WTD Remedial Drilling and Grouting As-Built Report		Original -V.00
2020/08/10	669034-0000-4GER-0001	Technical Report

**TITLE:** **TECHNICAL SPECIFICATIONS FOR THE  
WHALE TAIL DIKE FOUNDATION BLANKET GROUTING**

**PROJECT:** **REMEDIAL WORK FOR WTD SEEPAGE**

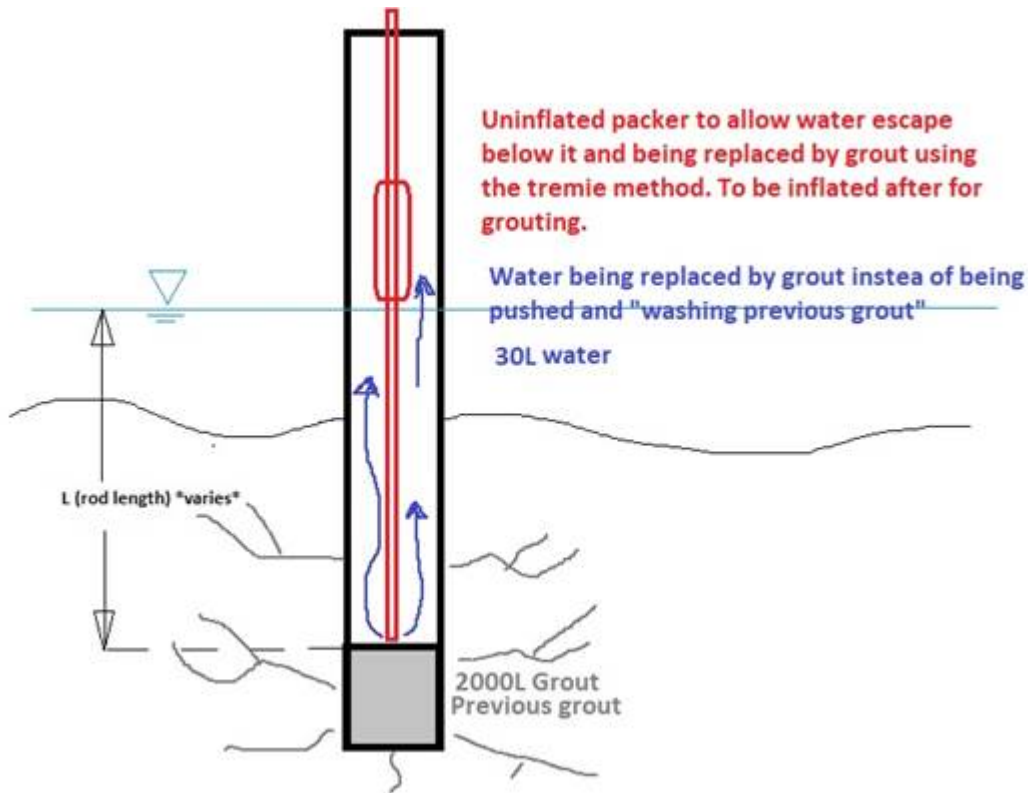
As discussed during our morning meeting, SNC came up with the proposal to carry an extra step prior re-grouting every hole which is an add to the specifications as well as Mix use directives issued yesterday.

It consists of set upping the packer above the water table with a specific rod length below to reach the previous grout elevation and then tremie grout. The theory being this is to flush the water in the casing out of the hole as opposed to push it with grout within the fractures as this may wash the previous injected grout if set time is not reached.

AEM is challenging this concept as it would evolve an extra packer arrangement and delays on every hole in order to solve this:

All in all, when adding extra steps adding more time and costs, AEM wants to make sure there is significant added value in doing so and I am not convinced at this point.

**Grouting Committee Meetings No. 5**  
**Presentation**  
**Meeting Minutes**

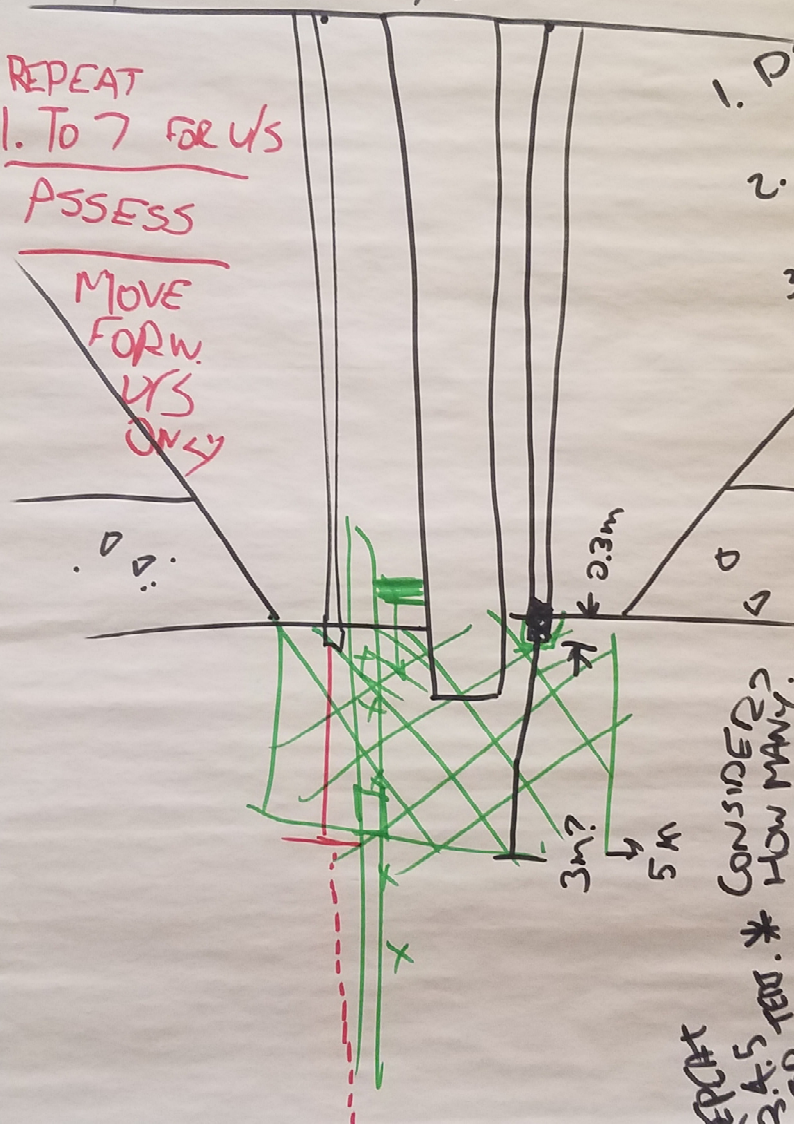
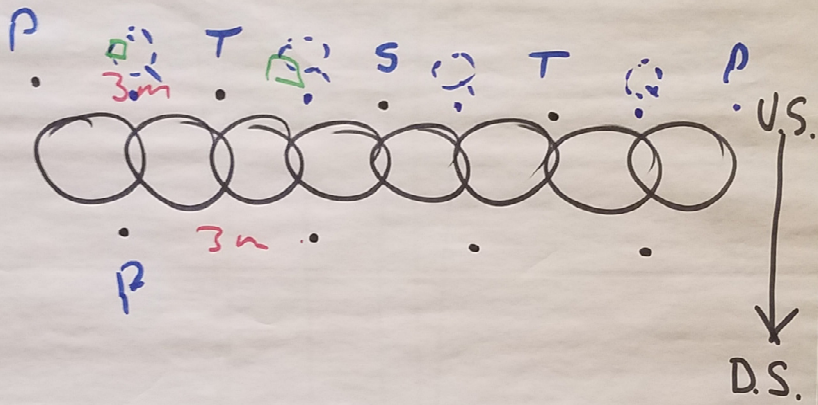
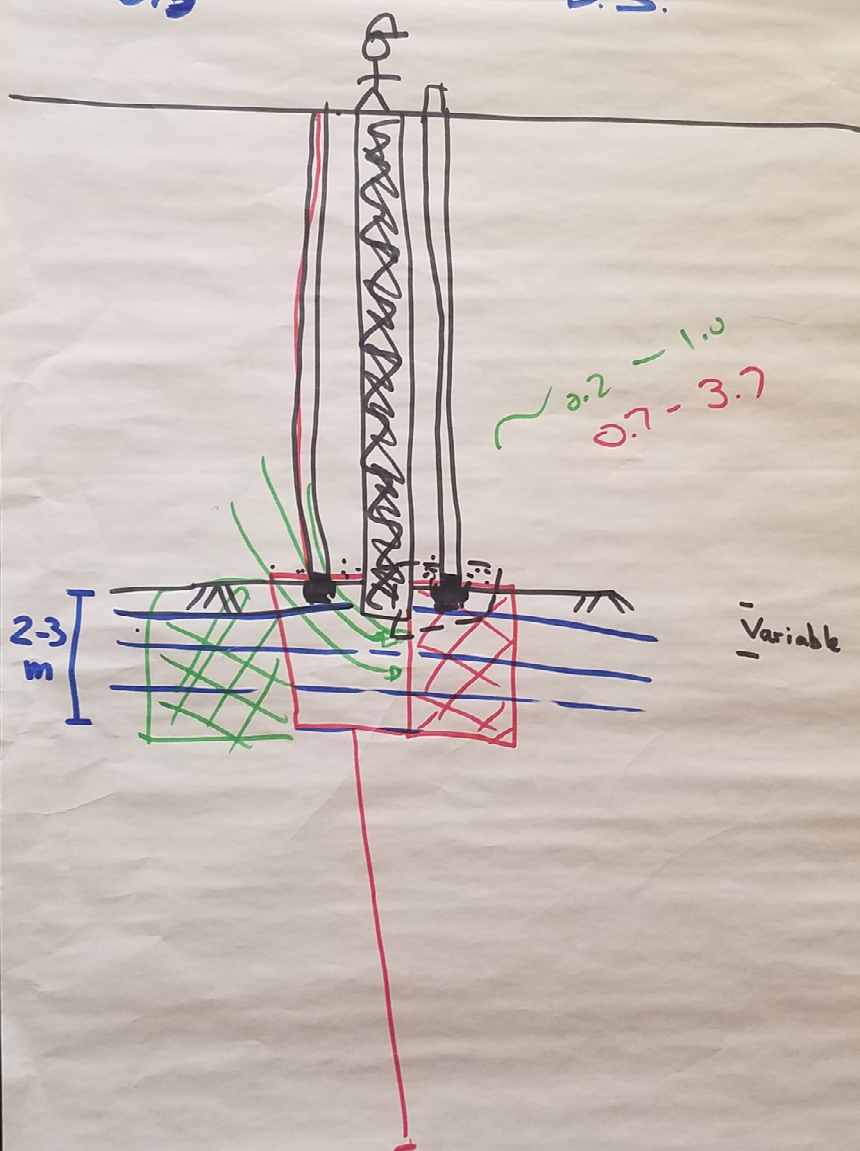
~~P, S, T~~  
~~12, 6, 3~~  
 U.S.

~~P, S, T~~  
~~12, 6, 3~~  
 D.S.

1. DS ALL CASINGS
2. BOTTOM PLUG
3. D/S PRIM VARIES

REPORT  
 3.4.5 TEND. \* CONSIDER 2? HOW MANY?  
 7. FOR  
 REPEAT 5. COMPLETE  
 3.4.5. DEPTH 0.5:1 + CCH + WHEN NEED. CELEST

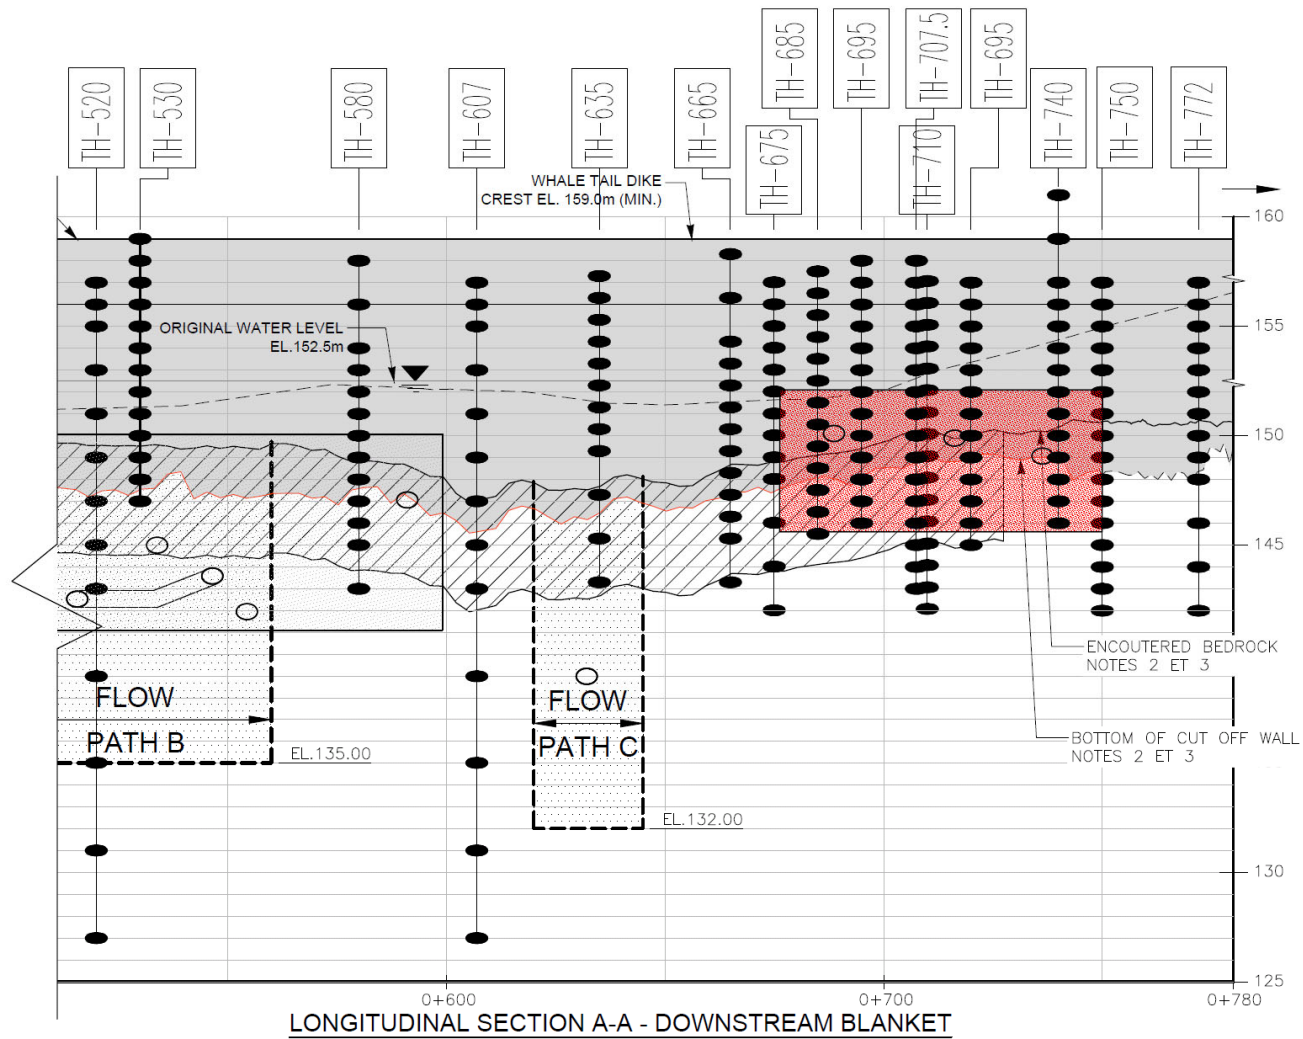
Had to re-grout more than one time due to grout drop and leaving 3-4 m hole empty;

Refusal criteria may not feasible and reasonable in the Specs?

Flush set grouting currently is not ready at the site, which is required as per Specs;

## DRILLING AND GROUTING STRATEGY SECTION 0+520 TO 0+750

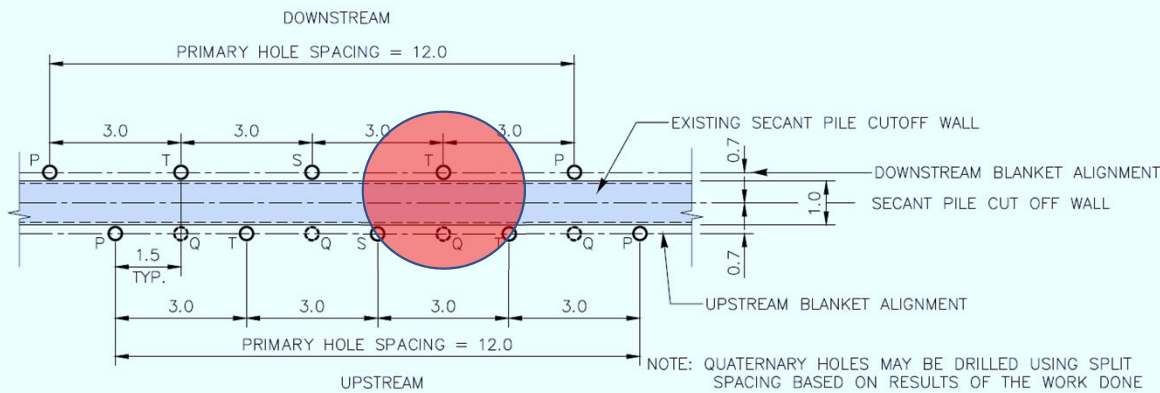
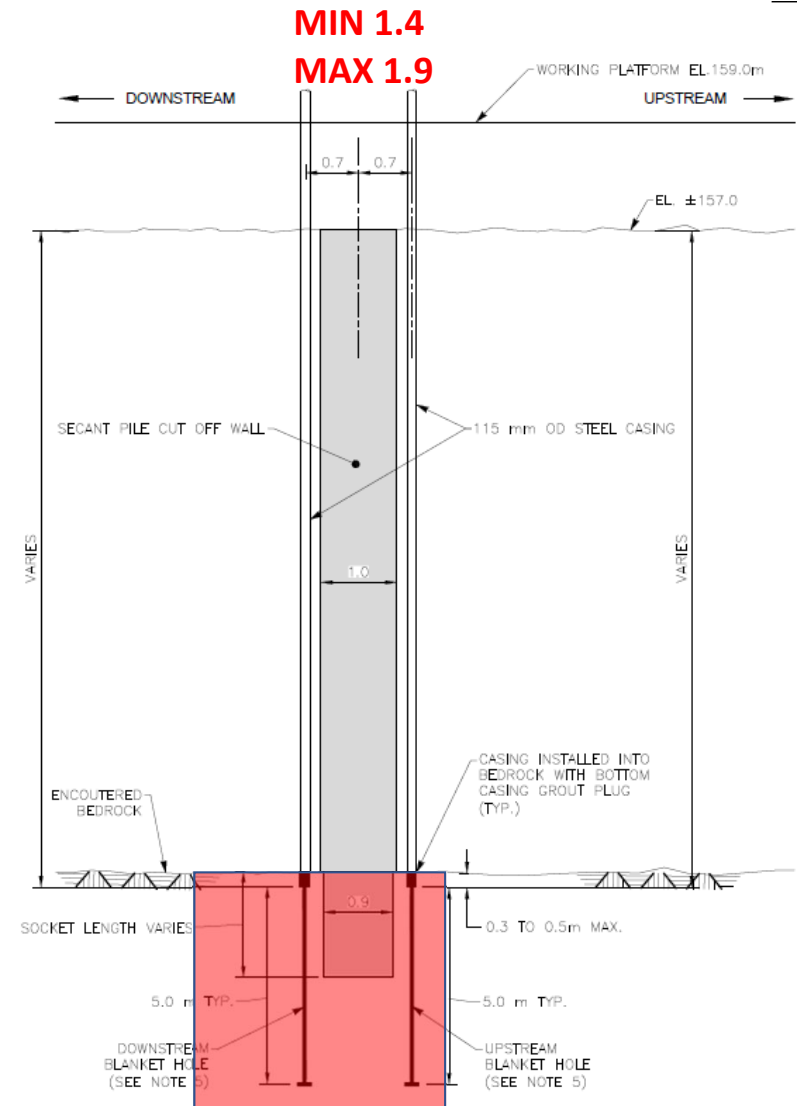
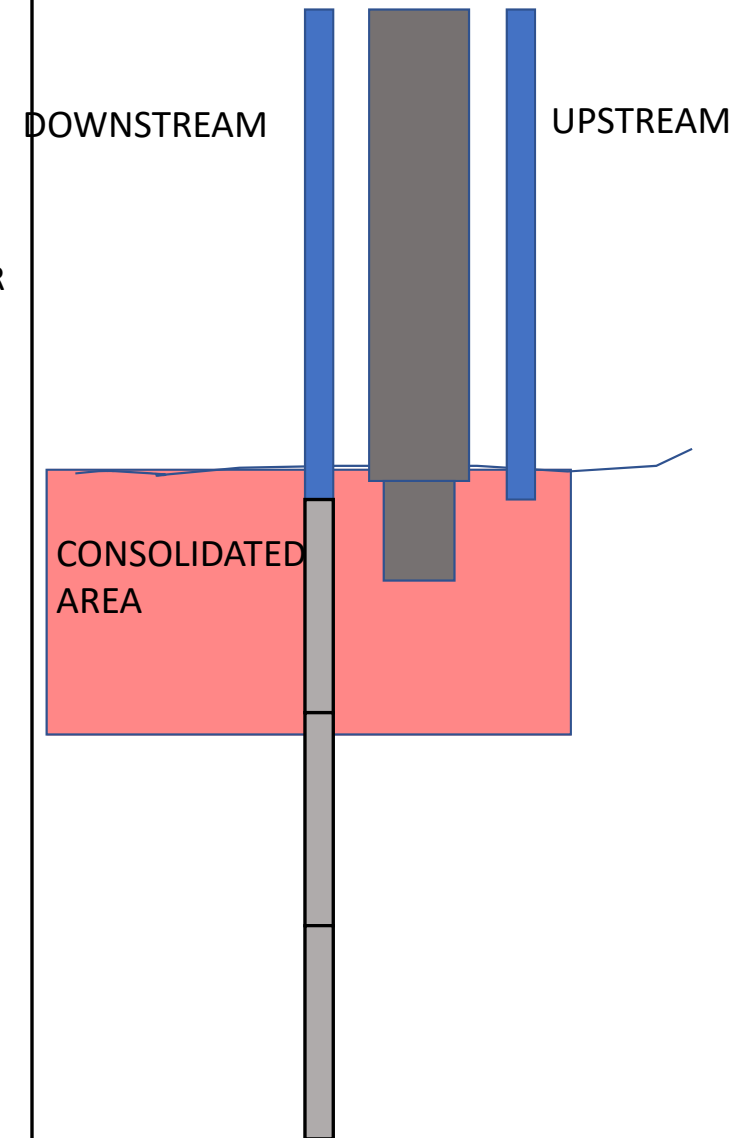
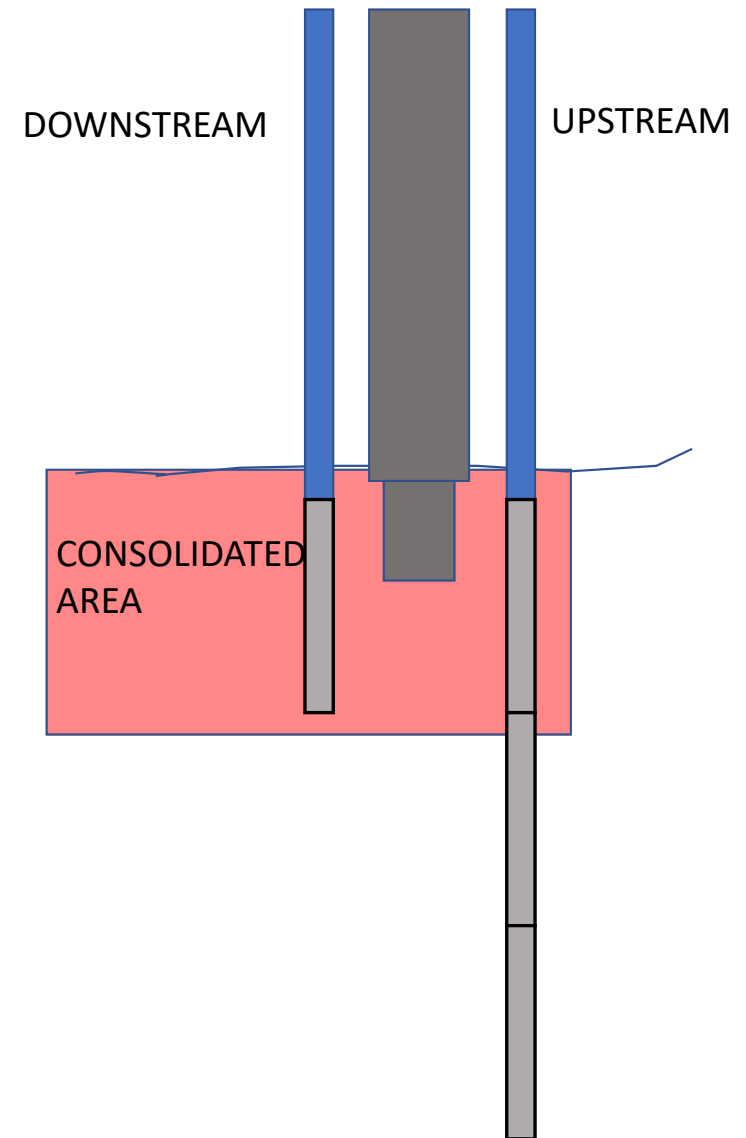
GROUTING OF DOWNSTREAM BLANKET CONSOLIDATED THE UPPER PORTION OF THE ROCK FOUNDATION OF THE UPSTREAM BLANKET BECAUSE OF THE CLOSE DISTANCE (1.4 TO 1.9 m) BETWEEN BLANKETS

- DRILL AND GROUT DOWNSTREAM CURTAIN HOLES P AND S 15 m IN ROCK. UPSTAGE WHERE POSSIBLE AND DOWNSTAGE IF HOLE IS CAVING. START WITH P THEN S.
- DRILL AND GROUT T HOLES . T LENGTH WILL BE BASED ON S HOLES MIN 10 m, MAX 15 m.
- DRILL AND GROUT Q HOLES BASED ON GROUT TAKE IN T HOLES, Q LENGTH WILL BE BASED ON T HIGH GROUT TAKE STAGE.

- DRILL AND GROUT UPSTREAM CURTAIN HOLES P AND S 15 m IN ROCK. UPSTAGE WHERE POSSIBLE AND DOWNSTAGE IF HOLE IS CAVING. START WITH P THEN S.
- DRILL AND GROUT T HOLES . T LENGTH WILL BE BASED ON S HOLES MIN 10 m, MAX 15 m.
- DRILL AND GROUT Q HOLES BASED ON GROUT TAKE IN T HOLES, Q LENGTH WILL BE BASED ON T HIGH GROUT TAKE STAGE.
